Environmental Review Team
Report
on

Laurel Crest Subdivision
Clinton, Connecticut

September 1978

LOCATION PLAN & DEVELOPMENT KEY

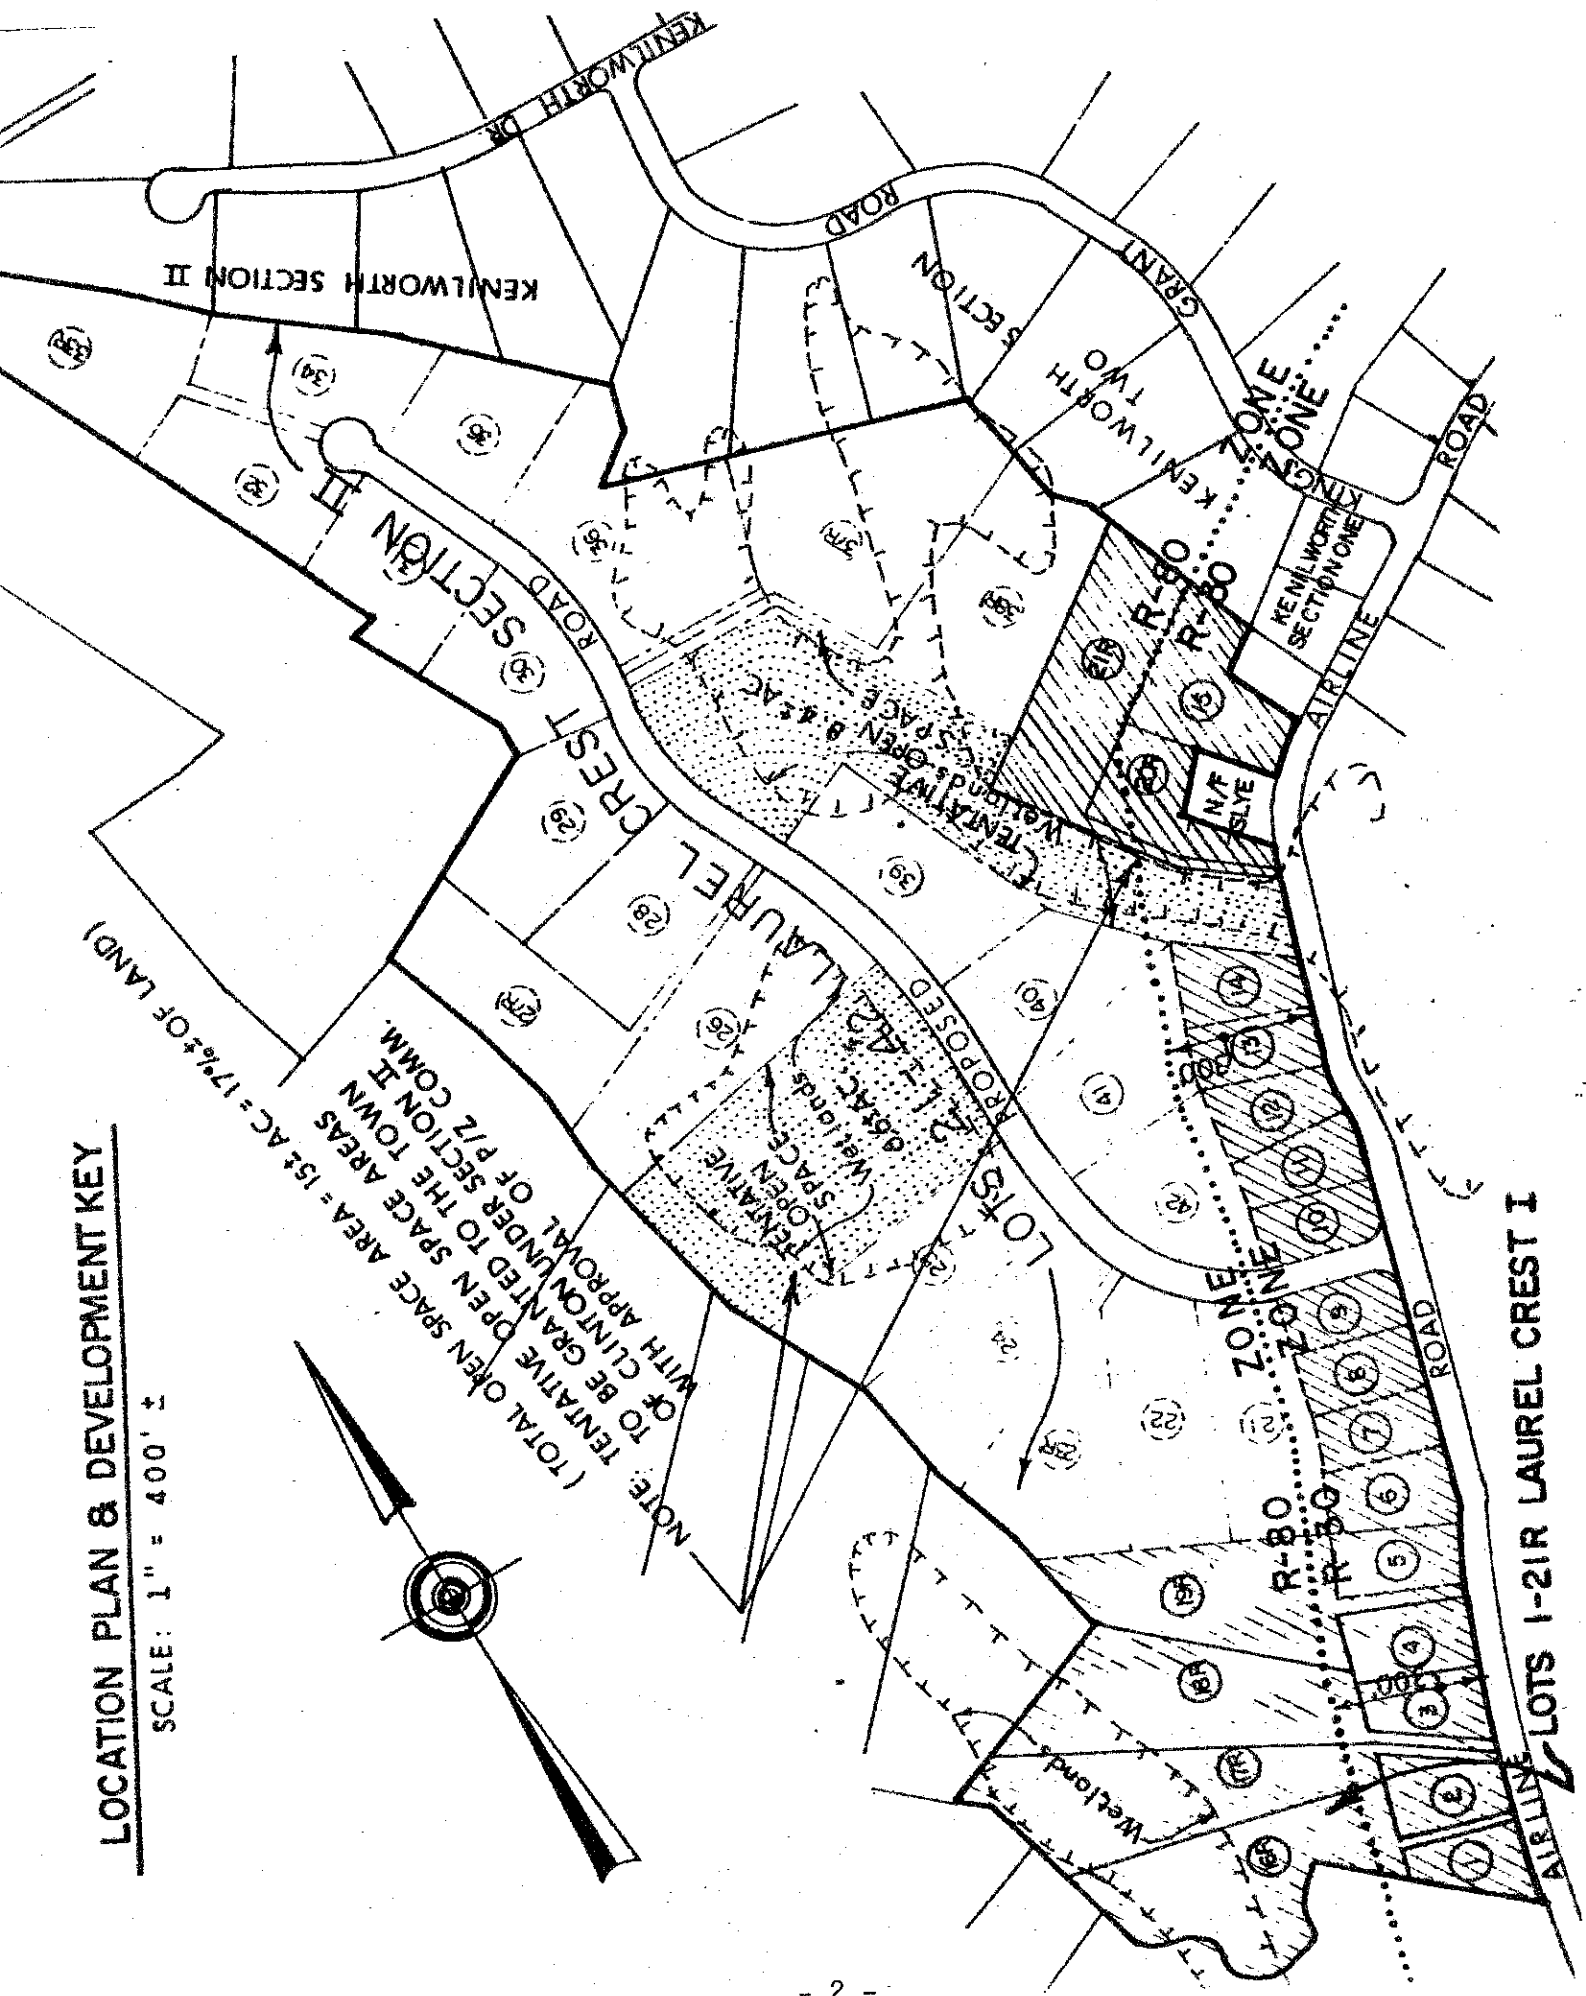
Laurel Crest, Section I, includes 21 proposed lots. Lots 1 through 15 average approximately 3/4 of an acre in size and are located on soils which have severe limitations for on-site septic systems. These lots are indicated on the site plan as requiring an engineered subsurface sewerage design. Although the subdivision plan has been approved by the Director of Health and the Town Engineer, the Planning and Zoning Commission has no guarantee that the systems will function properly after they are built. The State of Connecticut Department of Public Health recommends a minimum of one acre for on-site septic systems on soils which are considered favorable for on-site subsurface sewage disposal.

Many towns now prefer that engineered subsurface sewage disposal systems be in place on the lots and tested by the Director of Health before final approval for the proposed lots is given. With so many marginal lots, the Planning and Zoning Commission is taking a considerable risk in approving each lot without this stipulation. In this case, it would seem reasonable to require the systems to be tested after the engineered design is in place. Conditional approval could be granted at the present time and, if the Commission is so inclined, the map need not be signed until the required work on engineered systems is completed. If the developer is anxious to proceed with the lots on which engineered subsurface sewerage disposal design is not necessary, a revised map could be submitted to the Commission on which the lots requiring engineering are labeled "Not approved building lots". When the lots have been tested after the systems are in place, then these designations could be removed from the final subdivision map. Another option which might be explored by the Commission is to require the developer to combine lots which may have difficulty including both on-site septic systems and wells.

The proposed road for Laurel Crest Section II (lots 21-42) is approximately 2,900 feet long and is indicated as a cul-de-sac road. Section 4.4.6 of the Clinton Subdivision Regulations require that a cul-de-sac road shall not exceed a length of 1,000 feet and shall provide sole access to no more than 20 lots. The road is currently shown as serving 22 lots.

This proposed road will end approximately 500 feet from Kenilworth Road in the neighboring Kenilworth subdivision. Overall traffic circulation and public safety considerations warrant the Commission's insistence on requiring the developer to connect, if at all possible, this proposed road with Kenilworth Road.

LEGEND

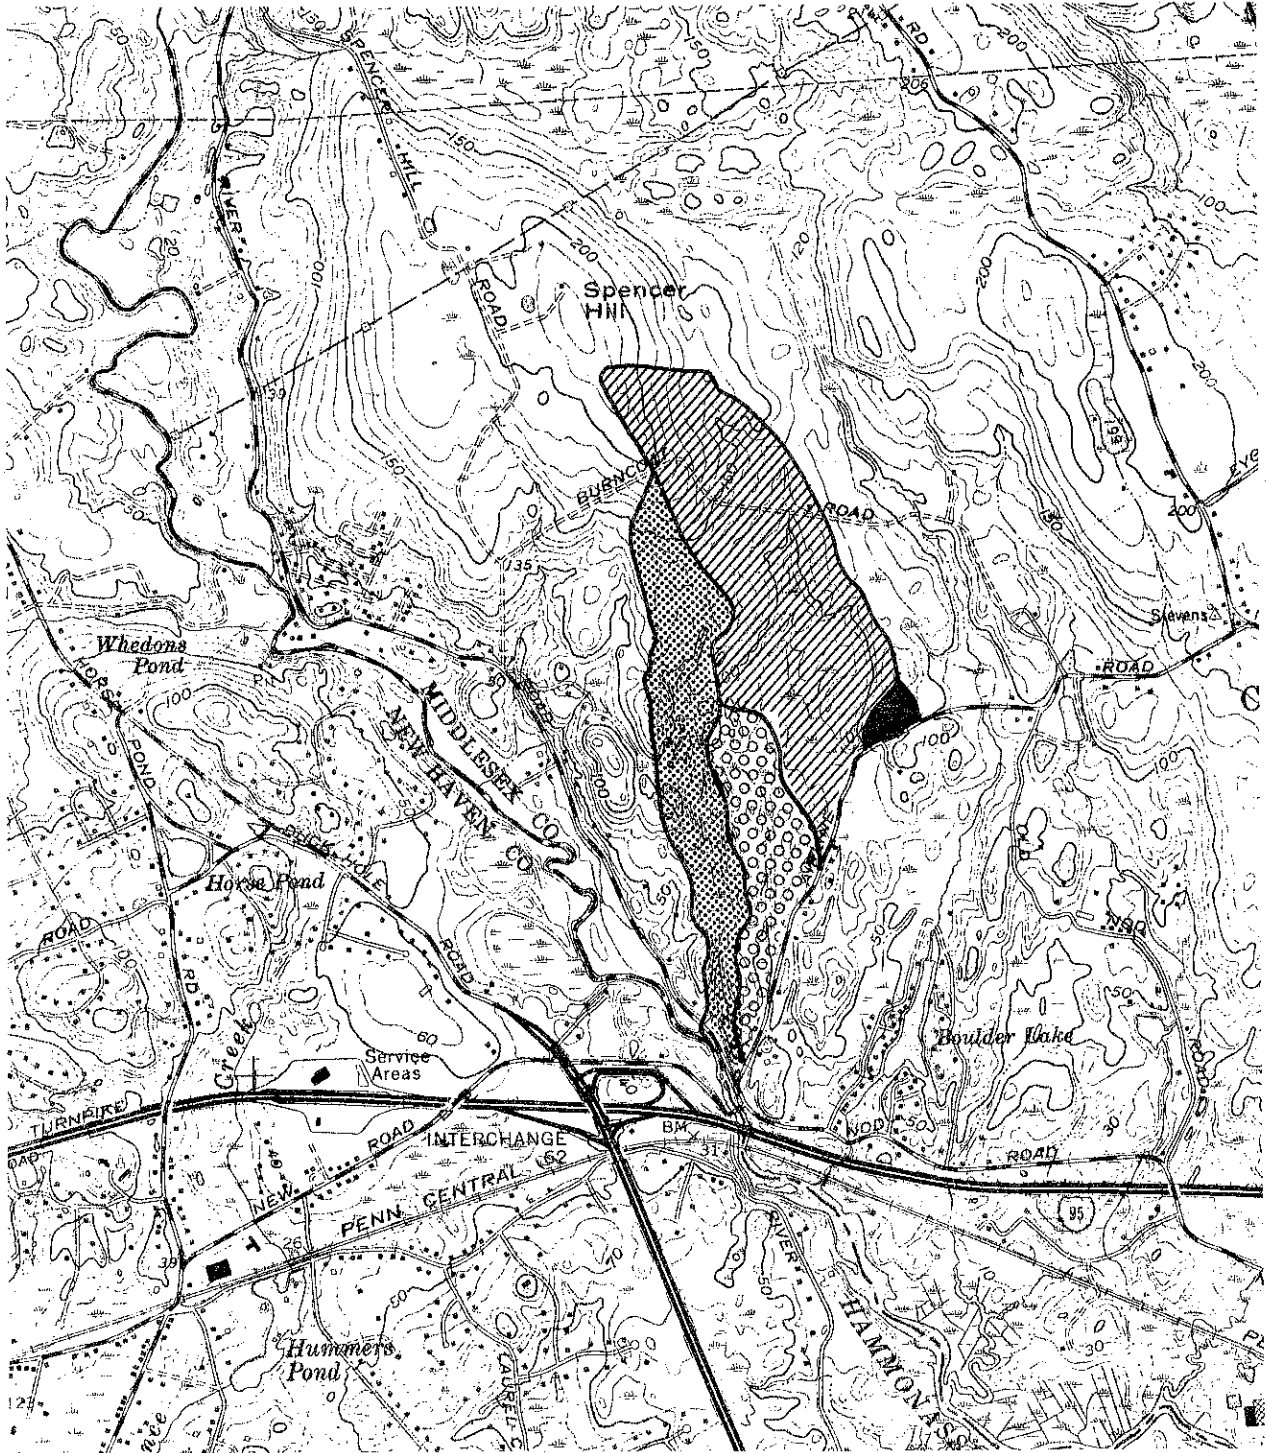
Development of the property is likely to have a profound effect upon drainage patterns. Because no definite plans are available for the interior part of the property, it is difficult to assess the probable extent of this effect. Of the three largest watersheds, it seems likely that watershed 2 will experience the most significant changes, as the percentage of land to be developed in that area (including those lots with direct frontage on Airline Road) is higher than in the others. The change would be in the form of increased runoff. Most of the increase would be expected to result from the building of roofs, driveways, roads, and other impervious surfaces over otherwise permeable land. Artificial storm water channelization would also have an effect upon peak runoff flows. However, in this proposed subdivision, it is likely that some of the most significant hydrologic changes would result from the tremendous amount of land reshaping that will be necessary for development. Because of the prominence of bedrock, blasting, as well as normal cutting and filling, probably will be needed in at least some interior sections to provide sufficient grading for the proposed new road and for house foundations. Topographic modification on such a scale can easily affect surface flow patterns, and blasting can affect subsurface flow paths.
